THE PORTLAND BUILDING

RECONSTRUCTION PROJECT

HISTORIC LANDMARKS
COMMISSION HEARING
LU 17-153413 HRMAD

JUNE 26, 2017

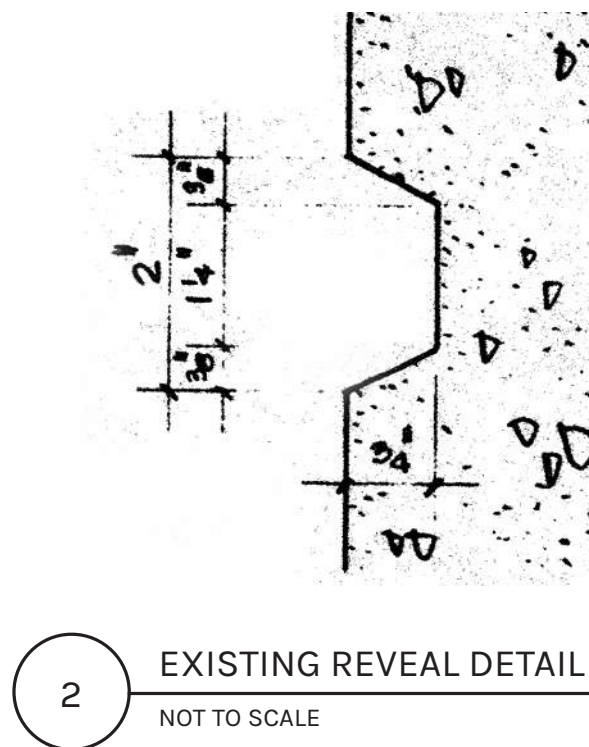
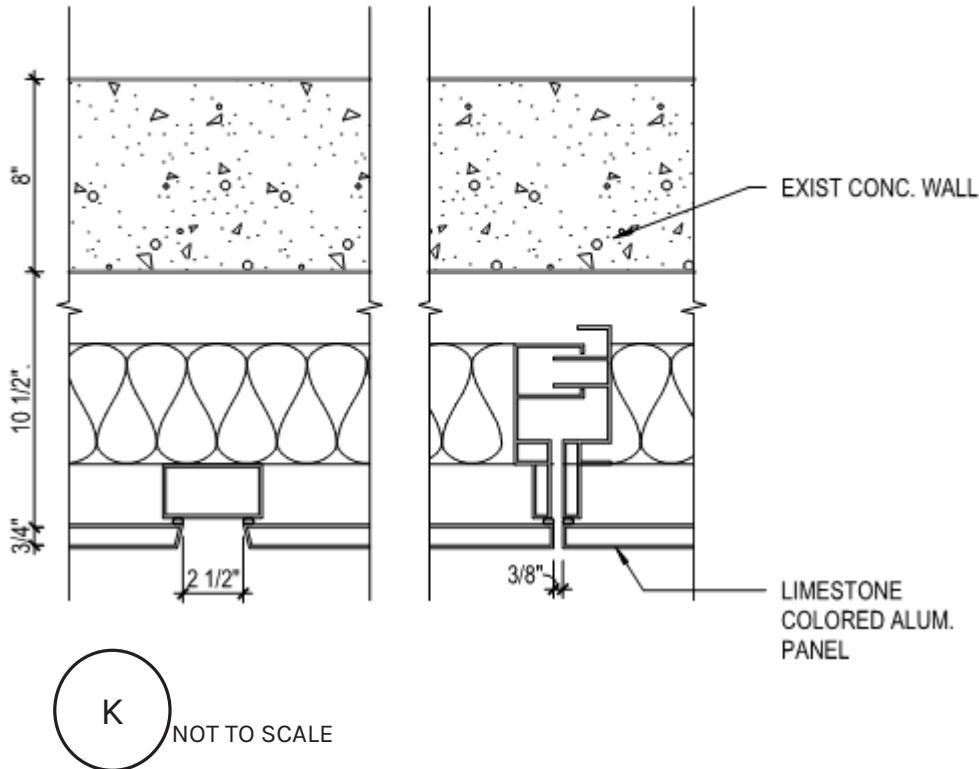
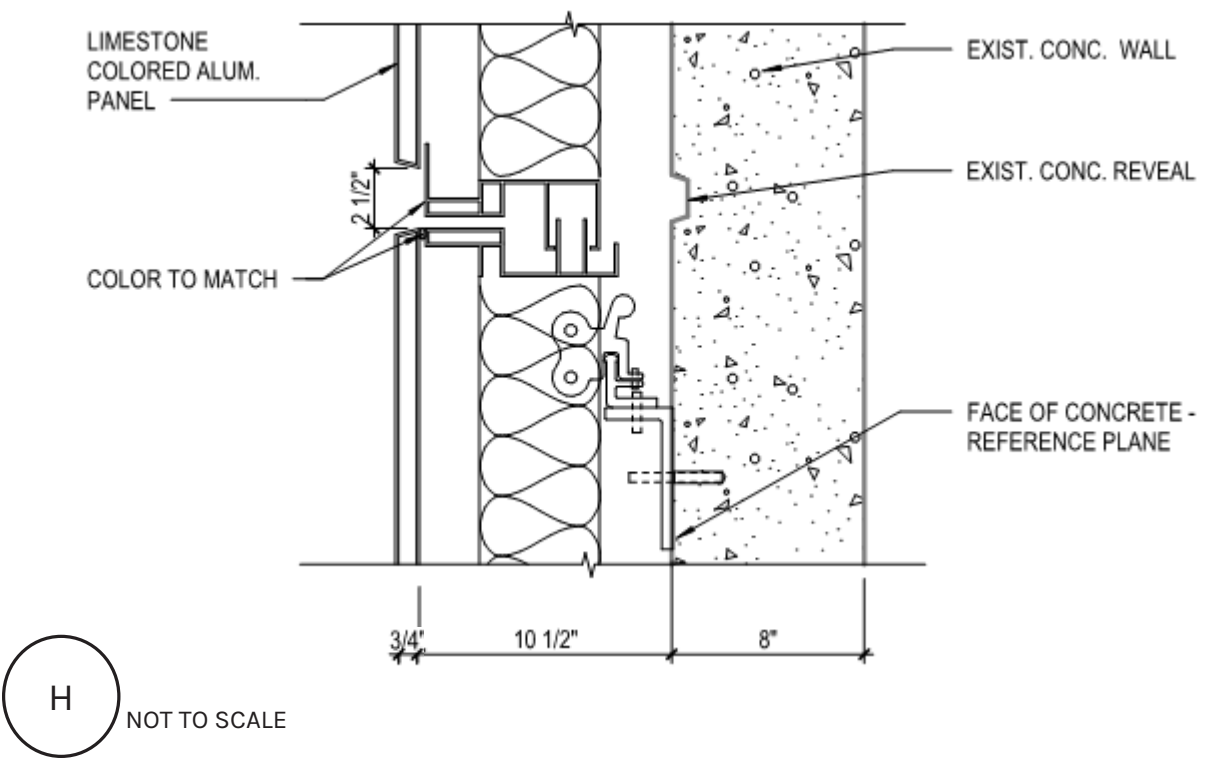
D) The "score lines" of the new panel at floors 4-14 shall be 3/4" deep.

“Staff notes, however, that the proposed “score line” in the new system appears to be only the depth of the metal panel (1/8”) whereas the existing score lines in the concrete are 6/8”; this is detailed on sheek 91, detail “K” and “2”, respectively. In order to be more compatible with the existing condition, this detail should be revised to ensure a 3/4” score line”

Response: Dimensions were not properly annotated on submittal. Reveal depth is confirmed to be 3/4" as shown below and was not intended to be less.
